INSTRUCTION TO SERVICE

ITS: 60312		NOV/5/2021
SECTION:	260-BATTERY COMPARTMENT	
WRITTEN BY:	Ilan Kizner	
SUBJECT:	Rework – High voltage receptacle assembly.	
ISSUE:	Failing DC Contactors	
SUMMARY:	Issue identified as low-quality crimping of lugs on the receptacle side

ITS60312

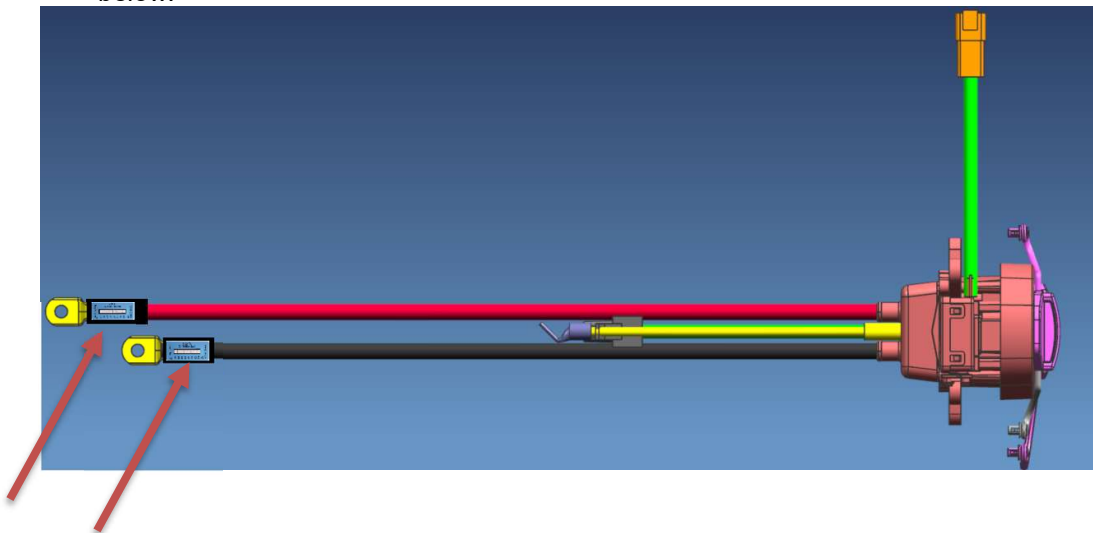
3.8. After the rework is done apply thermal strips on each of the HV cable ring terminals heatshrink as shown below:

Appendix A – Receptacle assembly rework procedure.

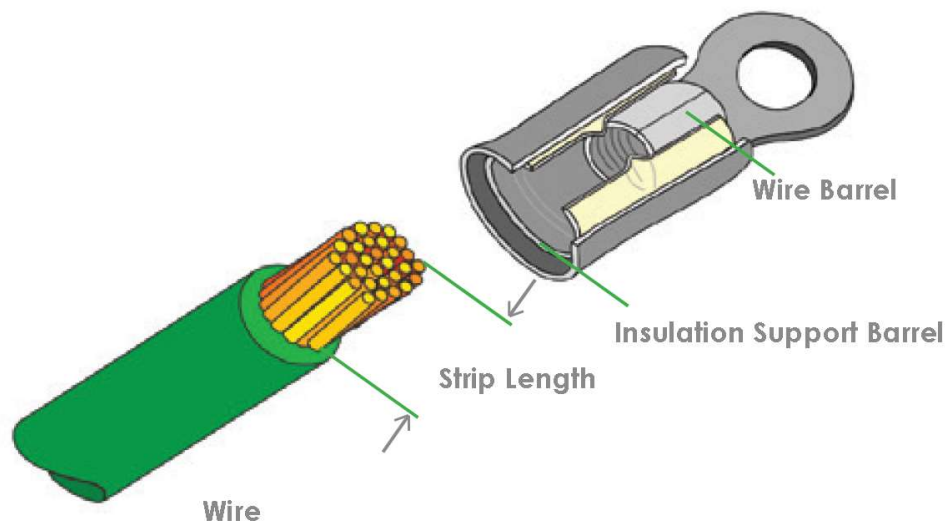
**** Note: the following rework applies to both positive and negative receptacle assemblies HV cables (674318 and 752163). The maximum length that can be cut from the existing cable should not exceed 3" inches in total.**

1. Remove heat shrink from the HV positive and negative ring terminals cables.
2. Cut existing ring terminal using cable cutter 6490350.
3. Remove outer insulation jacket and shield 5" back from cable using cable splitter 6490351.
4. Use heat shrink NFI part number 136365 to cover outer insulation and exposed shield extending to the HV cable.
5. Strip 1" inch of the exposed cable and visually inspect for signs of heat damage and discoloration. Any damaged cable strands should be removed.
6. Use crimping tool 6490348 to crimp ring terminal 640366 on striped wire.

****Note: For ring terminal 640366, strip length should be 1" inch.**

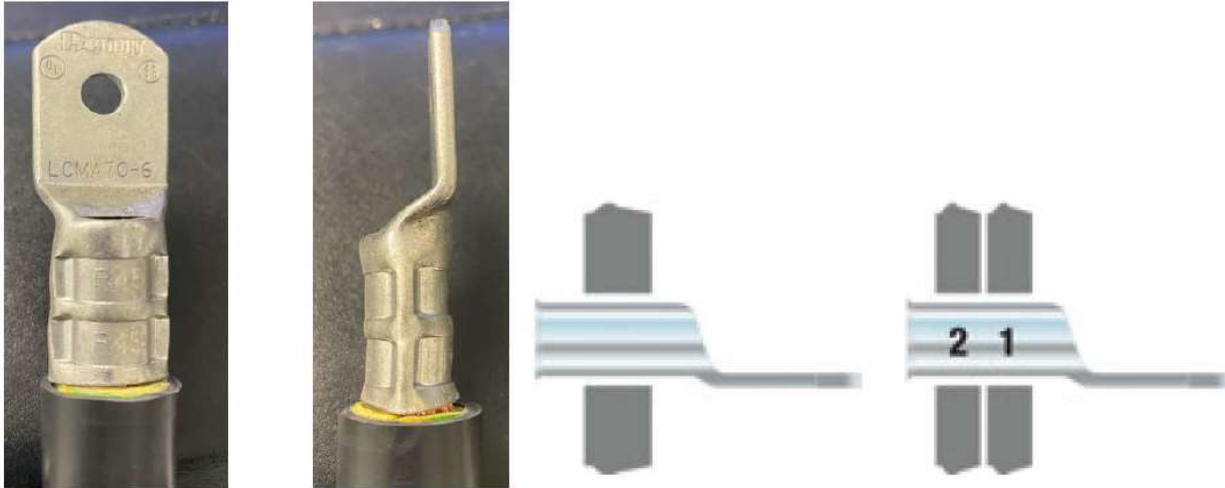
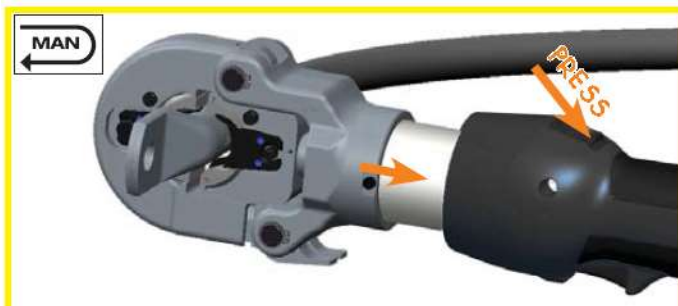
****Note: For the following ring terminal and cable a double crimp should be applied. Crimp should be in order 1, 2 as shown in the pictures below:**

14. Align the ring terminal on location 1 and press the trigger to start crimping. The head will release itself when crimping is complete. After the crimping is complete, release the trigger.

15. After the first crimp is done press the release button to release the cable, align the ring terminal to position 2 and repeat the crimping operation again. If for some reason the crimp process is stopped then use the upper trigger to release the crimp head.
